Wollongong Local Planning Panel Assessment Report | 27 April 2022

WLPP No.	Item No 3
DA No.	DA-2021/1282
Proposal	Residential – Conversion of existing dual occupancy into a single dwelling house and the construction of a new dwelling house to create a dual occupancy and Subdivision - Torrens title - two (2) lots
Property	8 Bellebrae Avenue, MOUNT OUSLEY NSW 2519 Lot 28 DP 33926
Applicant	Illawarra Drafting and Developments
Responsible Team	Development Assessment and Certification – City Centre Planning Team (VD)
Prior WLPP Meeting	N/A

ASSESSMENT REPORT AND RECOMMENDATION

Existing Floor Plans

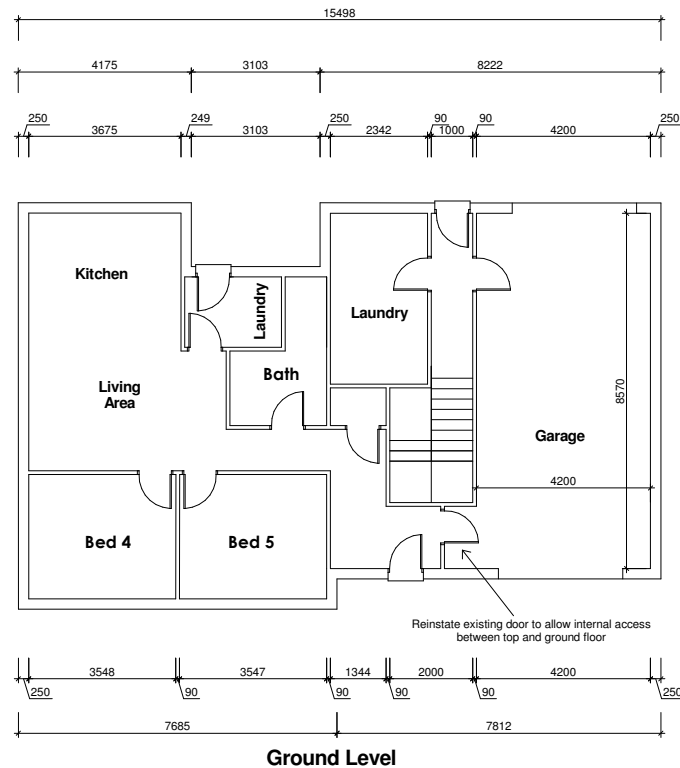
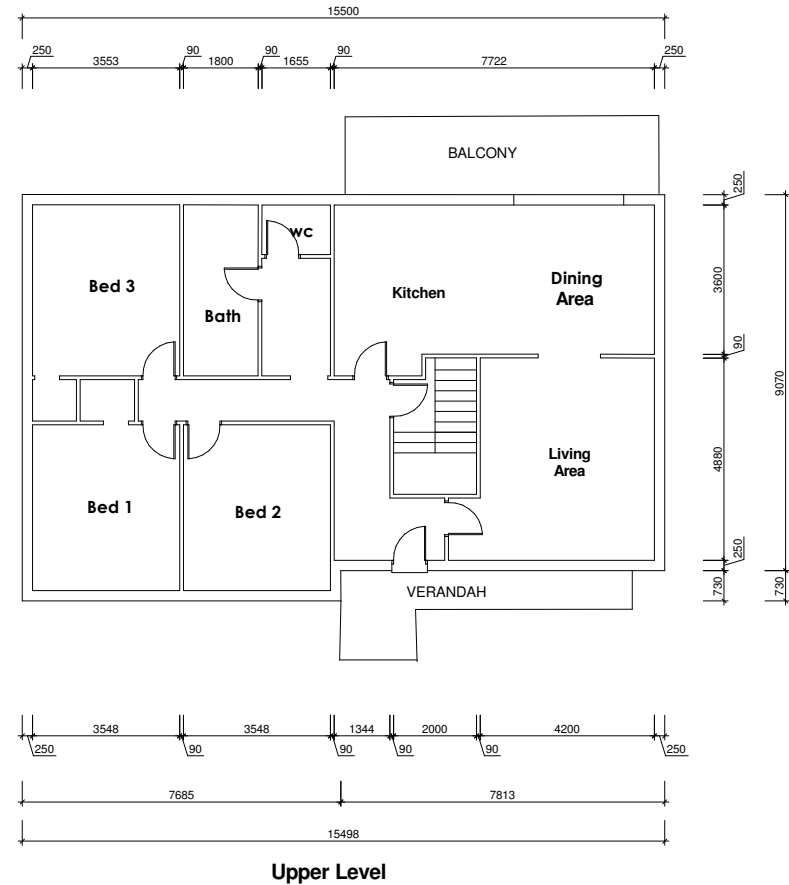
The internal door has been reinstated to allow for internal access between the lower and upper floor. The proposed conversion plans are outlined in Sheet No. 15 in **Attachment 2** along with a full set of architectural plans for the development.

It is recommended that a condition be imposed prohibiting the use of the lower level to be used as a separate dwelling. A condition is also proposed that DA-1984/690 be surrendered

Reinstate existing door to allow internal access between top and ground floor
